RE: – PA2026/0031: Response to Notice of Deferral
Lot 1462 Town of Darwin (4 Lindsay Street, Darwin CBD)

I refer to the above-mentioned Planning Application (PA2026/0031) for the purpose of 39 x 2-bedroom and 36 x 1-bedroom **serviced apartments** in a 9-storey building with two levels of basement car parking.

INITIAL CONCEPT DESIGN PRESENTATION

SK4- LEVEL 2 PLAN

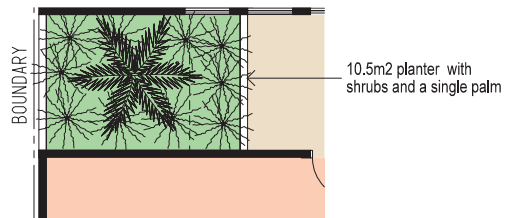
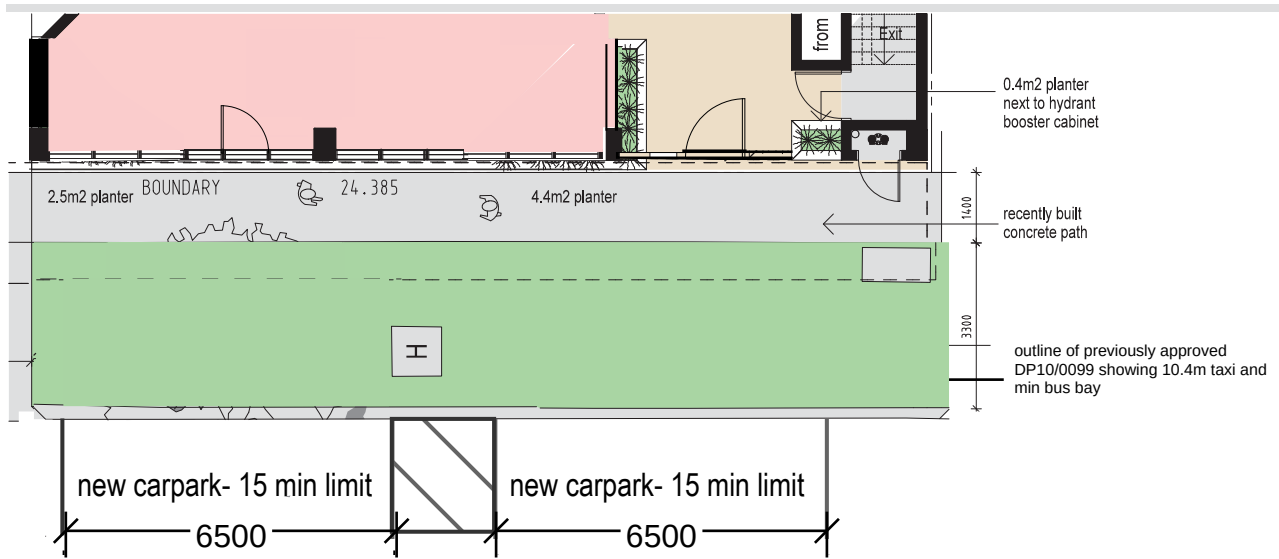
- (a) Demonstrate compliance at a minimum with either clause 5.4.6.2 (Private open space for dwelling-multiple) or clause 5.4.7 (Communal Open Space) of the Northern Territory Planning Scheme 2020 (NTPS 2020).*

(d) Detail the windows/openings located along the south-western elevation at the end of the central corridor on levels 2 to 9, particularly to clarify the extent of cross-ventilation.

The plans provided at **Attachment B** demonstrate a compliant communal open space area that is approximately 165m² where approximately 141m² is required by NTPS clause 5.4.7. This has been achieved by extending the cantilevered Level 2 floor plate approximately 1.7m towards the rear/south-east boundary (SK4 refers) consistent with Levels 3-9.

In relation to sub-clause 5.4.7(6)(b), bedroom 2 in units 3 and 4 includes a high-set openable window. These windows are designed to promote breeze flow and cross-ventilation in response to Deferral point 1(d) (discussed below). The windows will be openable/lockable from inside each unit with glazing incorporated to mitigate the potential for noise intrusion from the nearby communal open space area. Use of the communal open space area will also be restricted to respectable hours.

The plans have been updated to show the sliding doors to each balcony and windows to bedroom 2 for units 1-4 (L2) and units 1-4 & 10 (L3-9). An additional window to unit 7 (L3-9) has also been included adjacent to the kitchen/doorway entrance. This detail, and the increased breeze flow opportunities, are shown on SK4 and SK5 at **Attachment B**.
